AMENDMENT TO THE DRAWINGS

REMARKS

FIG. 1a

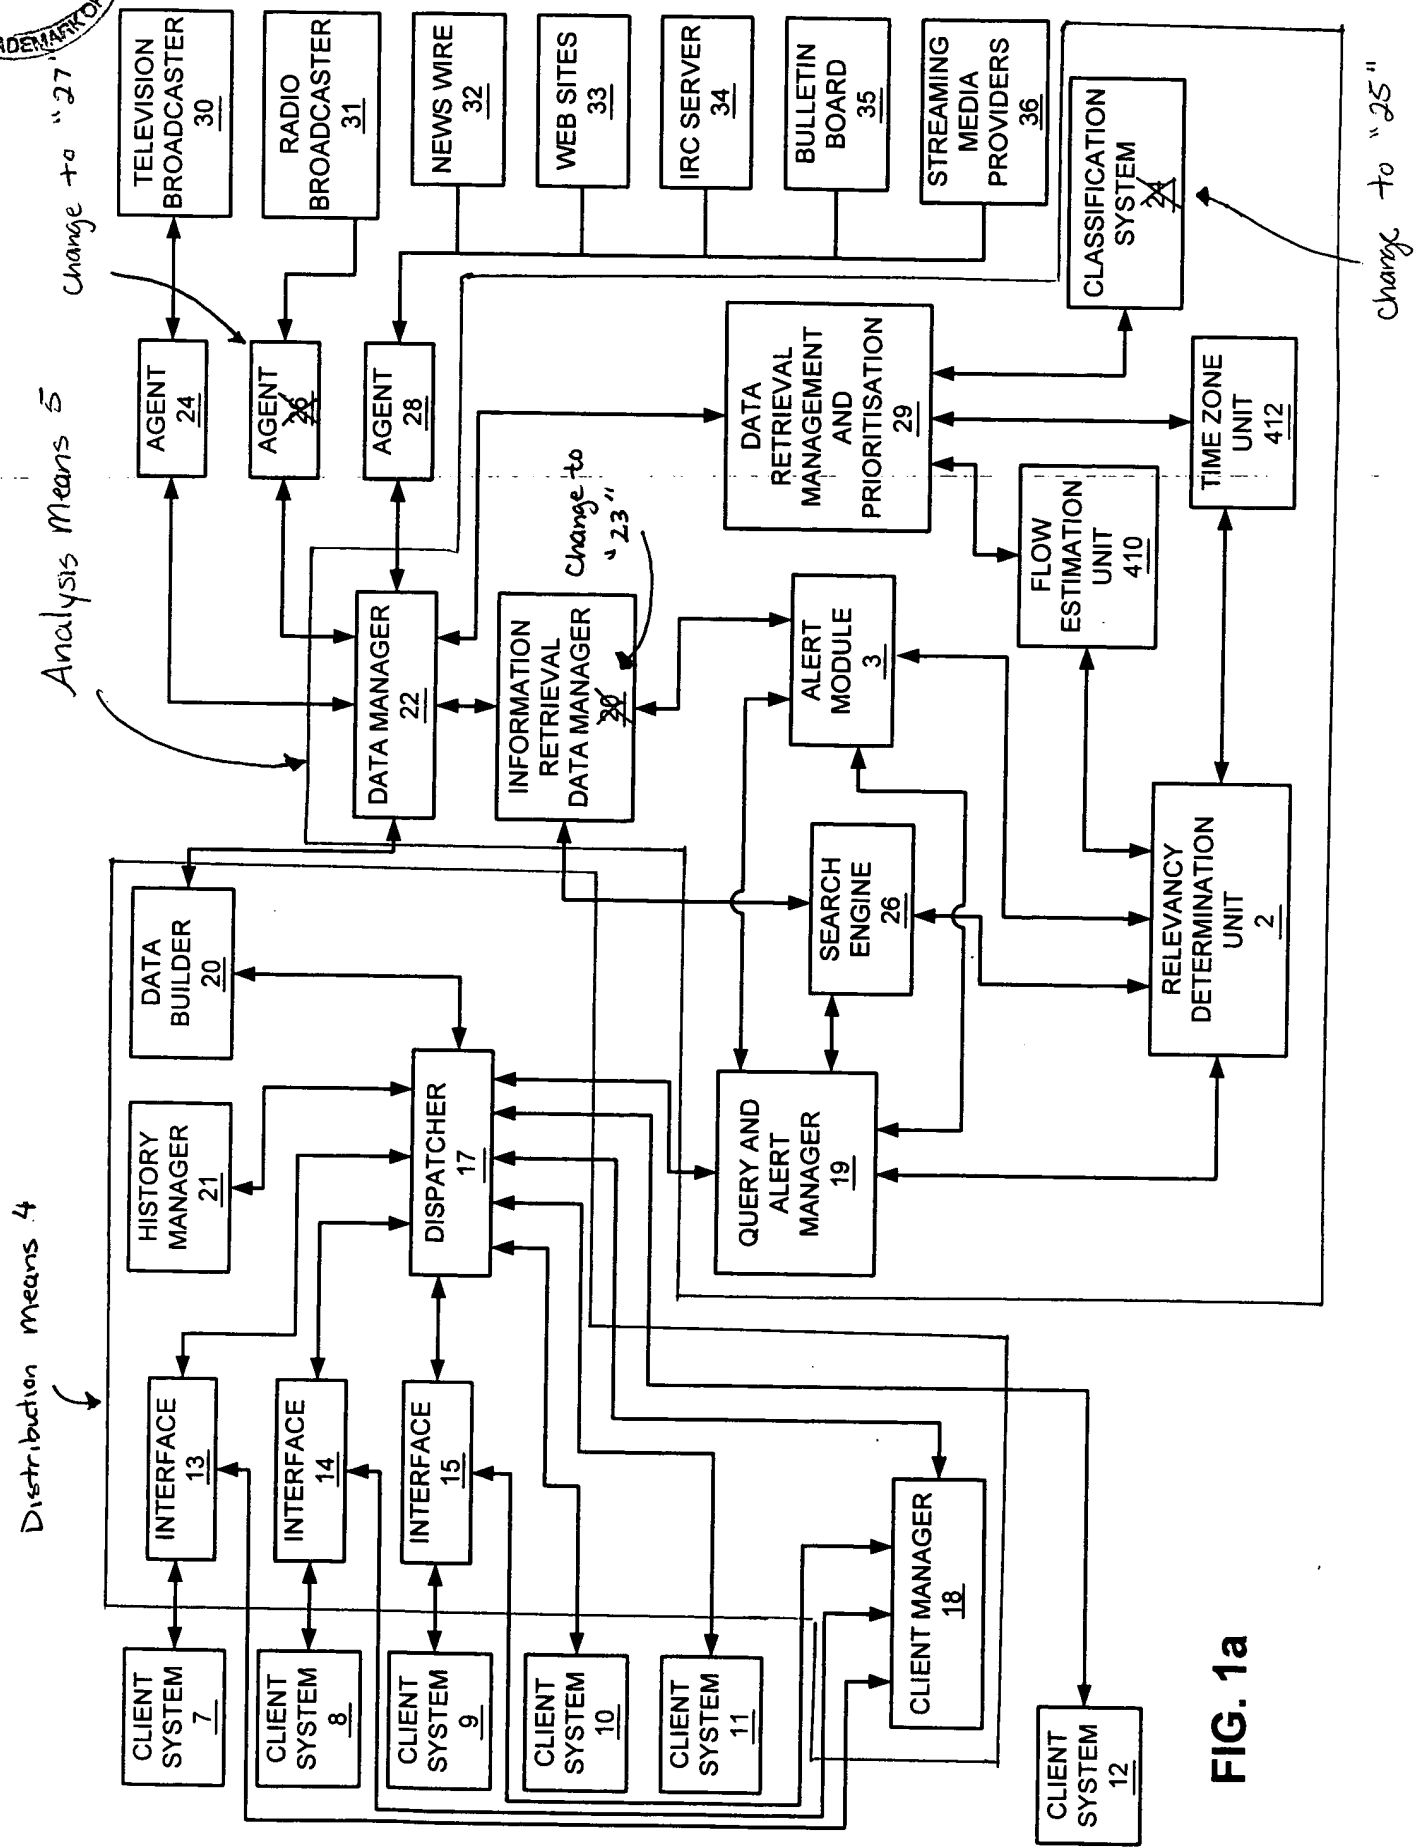
Figure 1a has been amended to add reference signs 4 and 5 described in the specification but inadvertently omitted in the figure. Figure 1a has also been amended to correct errors in the duplicative use of reference signs with respect to information retrieval data manager 20, agent 26 and classification system 24. "Information retrieval data manager 20" is now designated as "information retrieval data manager 23," "agent 26" is now designated as "agent 27" and "classification system 24" is now designated as "classification system 25". Amended figure 1a depicts the distribution means 4 to include: dispatcher 17, data builder 20, history manager 21, interfaces 13, 14, and 15, and client manager 18. Amended figure 1a also depicts the analysis means 5 to include: data manager 22, information retrieval data manager 23, alert module 3, search engine 26, query and alert manager 19, data retrieval management and prioritization 29, classification system 25, time zone unit 412, flow estimation unit 410, and relevancy determination unit 2.

Examiner objected to Figure 1a under 37 CFR 1.84(p)(5) because the figure does not include reference signs 4 and 5 mentioned in the description. Figure 1a has been amended to include reference signs 4 and 5. In light of the amended figure 1a, Applicants respectfully submit that figure 1a compiles with 37 CFR 1.84(p)(5), and respectfully request Examiner to withdraw this objection.

FIG. 3

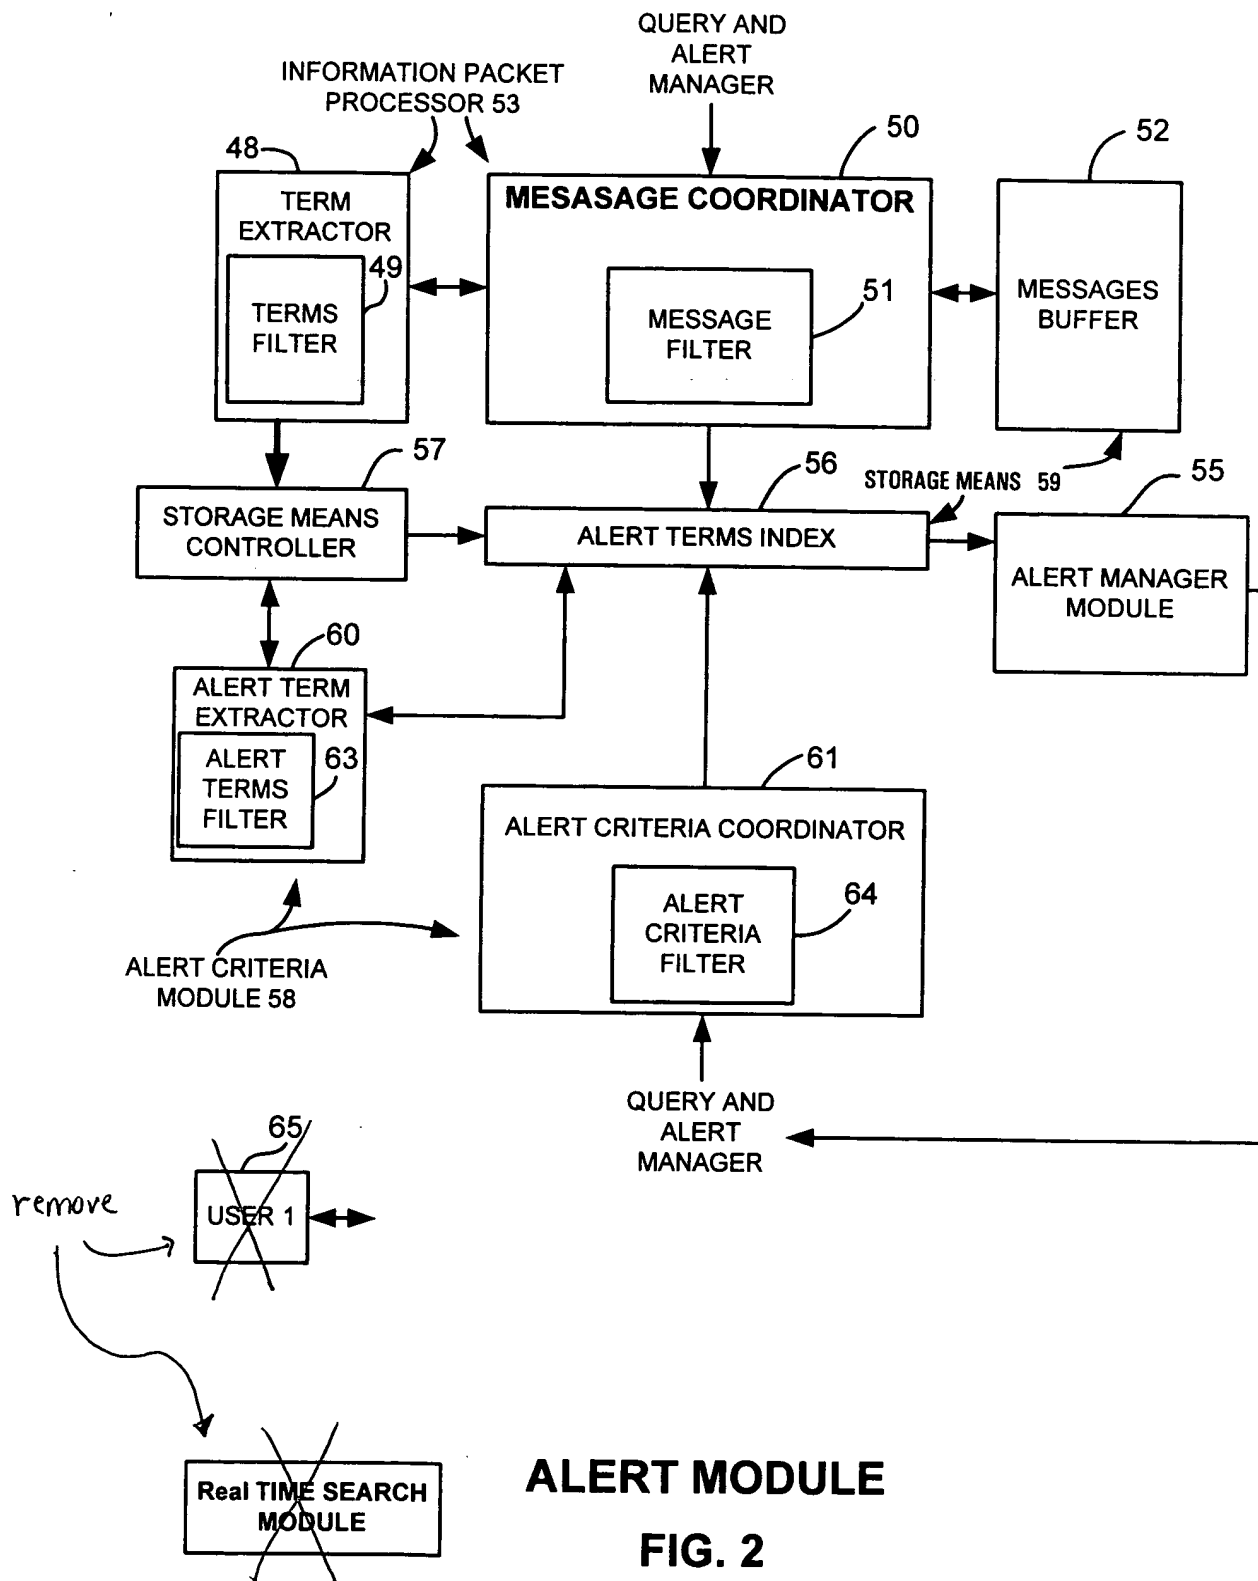
Figure 3 has been amended to depict a link from reference numeral 98 (the alert criteria ID) to reference numeral 97 (the "relevant alert criteria ID"). It has also been amended to depict a link from reference numeral 95 (the channel IDs that are in the channel map) to reference numeral 87 (the "channel ID").

Examiner objected to Figures 2-5 under CFR 1.84(h) because of the partial views in these figures.

FIG. 5

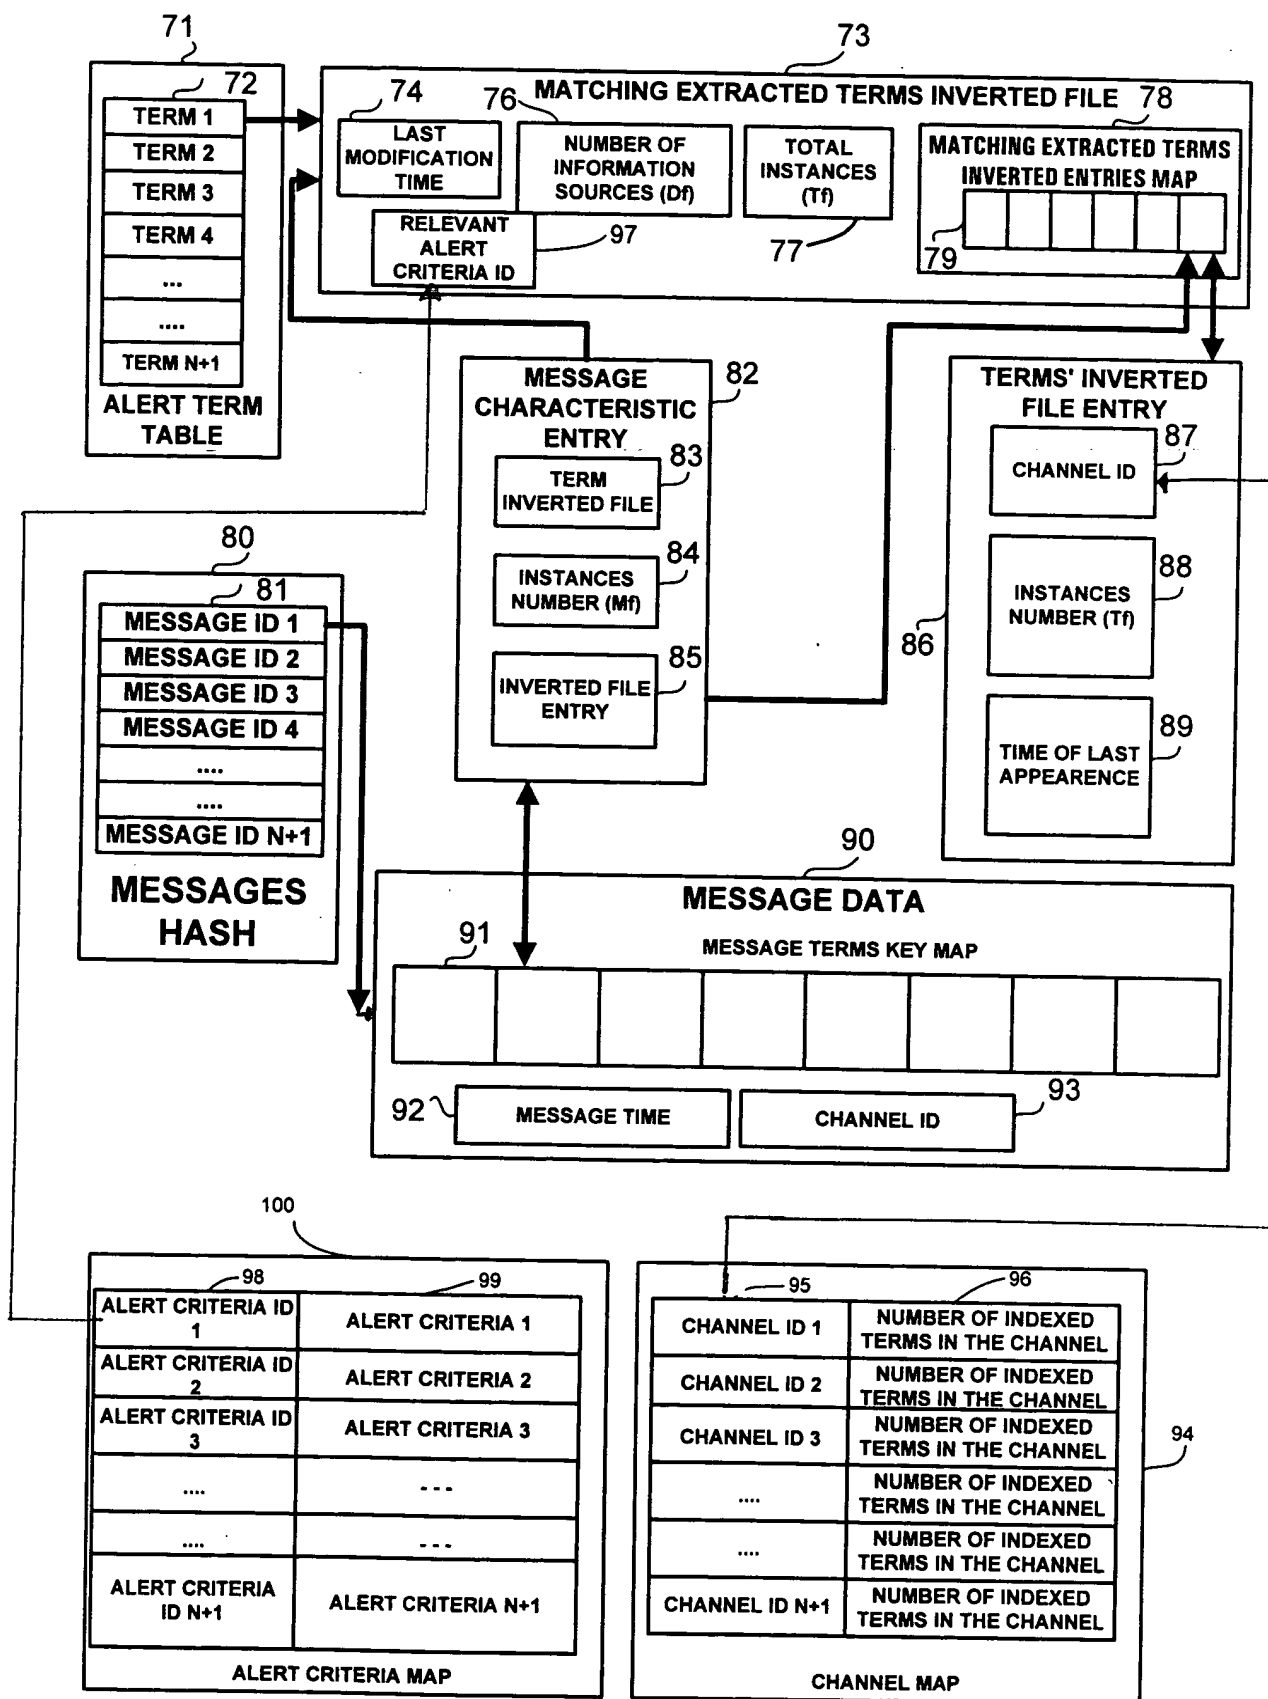
Figure 5 has been amended to depict a link from reference numeral 295 (the channel IDs in the channel map) to reference numeral 287 (the "channel ID").
